Technical Service Bulletin

15 Oil leak and/or camshaft DTCs stored - 3.0L

15 08 09 2005587/6 November 7, 2008. Supersedes Technical Service Bulletin Group 15 number 08-08 dated 2005587/5 for reasons listed below.

Model(s)	Year	VIN Range	Vehicle-Specific Equipment
A4	2002 – 2005	All	3.0L V6 Engine
A4 Cabriolet	2003 – 2006	All	
A6	2002 – 2004	All

Figure 1. The camshaft adjusters (A) and camshaft adjustment housings (B).

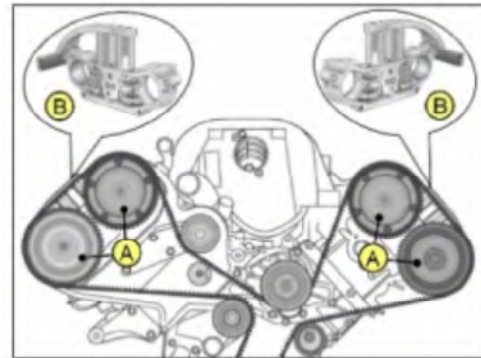
1. Check for a DTC for a camshaft position sensor (P0340 - P0348, P0365, P0368, P0390 - P0393).
Do not replace the camshaft adjusters (A) or the camshaft adjustment housings (B) if any camshaft position sensor DTC is present.

1. Do not replace the camshaft adjusters (Figure 1, A) or camshaft adjustment housings (Figure 1, B) because of these DTCs.
2. Follow Guided Fault Finding test plan for diagnosis.
3. Erase the DTC memory. These DTCs only occur during the break-in period of the cylinder head and are not causing the MIL.
4. Check for sufficient oil pressure. If the oil pressure is too low, also check for oil leaks from/around the camshaft adjusters.

Figure 2. The gasket (1), camshaft adjustment housing (B), camshaft sealing rings (2) and O-rings (3).

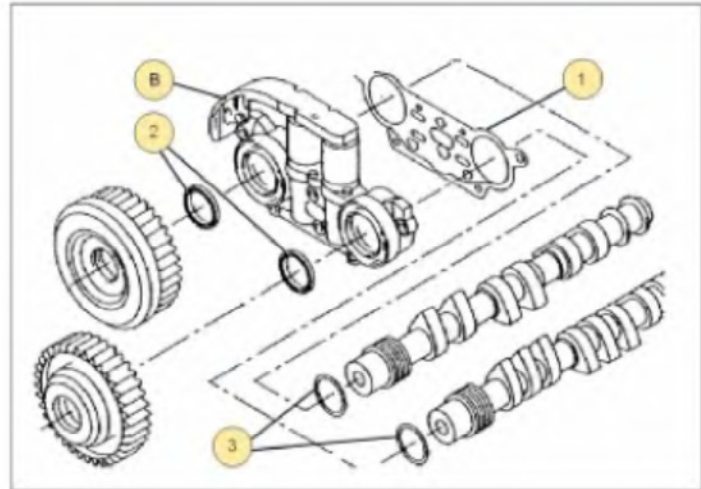
REVISION HISTORY		
Revision	Date	Purpose
6	-	<ul style="list-style-type: none">Revised <i>Service</i> (Step 5b and Figure 2)Revised <i>Warranty</i>Revised <i>Required Parts and Tools</i>

- a. Do not replace the camshaft adjusters (Figure 1, A) or camshaft adjustment housings (Figure 1, B)
- b. Replace gasket (Figure 2, 1) and O-rings (Figure 2, 3) between camshaft adjustment housing (Figure 2, B) and cylinder head.

Replace both camshaft sealing rings (Figure 2, 2) (See Repair Manual, Group 15, "Camshaft and camshaft adjusters, removing and installing")

Figure 3. The outer bolts (3), caps (4), and O-Rings (5).

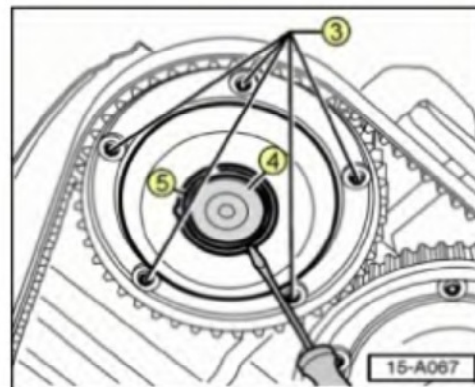
1. Retorque all five outer bolts (Figure 3, 3) on all four camshaft adjusters to 15 Nm. (The bolt heads are located on the back side of the camshaft adjuster gears.)
2. Replace missing or damaged bolts (part number WHT 003 121).
3. Replace caps (Figure 3, 4) and O-Rings (Figure 3, 5) and secure with securing ring (See Repair Manual, Group 15, "Camshaft and camshaft adjusters, removing and installing.")
4. Reassemble removed components and complete the repair.
